## STAFF REPORT

### HISTORIC DOWNTOWN ADVISORY COMMISSION

Thursday, November 16, 2017

### 3. AMENDMENT TO A FINAL DEVELOPMENT PLAN

#### Architectural Style and Elements (Page 6)

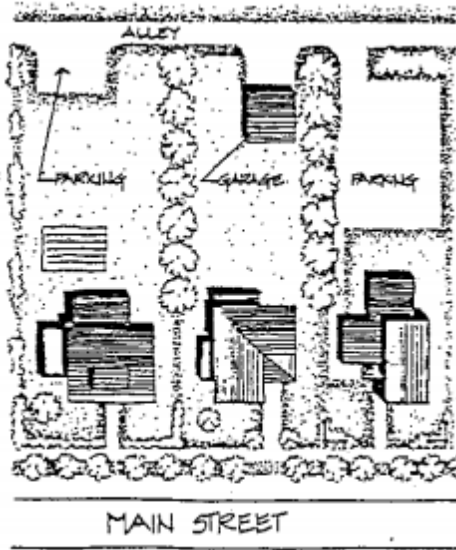
- The proposed project is generally in line with the architectural style recommended in the PAG.
  - The proposed building is in the general Midwestern rural aesthetic.
  - The existing building was added onto over time and although the building does not fit perfectly into the styles of the historic district, Staff feels that the improvement to the existing building using historic colors and materials. Furthermore, the building as it stands, has historic value as it is one of the older building in the downtown core.

## Architectural Elements (Page 46)

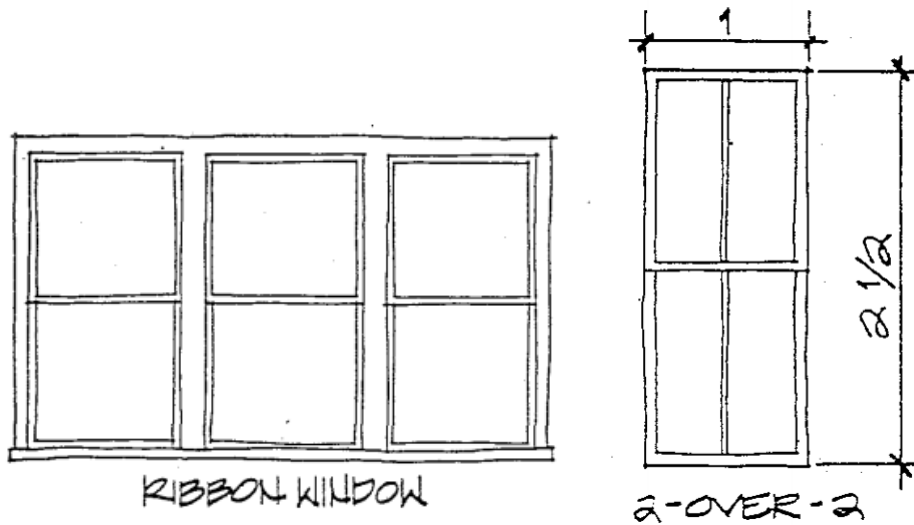
- The proposed project is somewhat in line with the PAG.
  - The front elevation of the proposal displays the Ribbon style, one of the three historically correct window styles with a 2-over-2 pattern. (Page 48)
    - Further examination by the Powell Architectural Advisor and HDAC is needed to determine whether the panels above the front windows are appropriate.

- A palette of generally darker colors with a few of the earlier, lighter colors persisting. More vivid contrast, and “picking out” of details is prevalent. (Page 73)
  - The selected green color were selected from a historic color palette and match other buildings within the downtown.
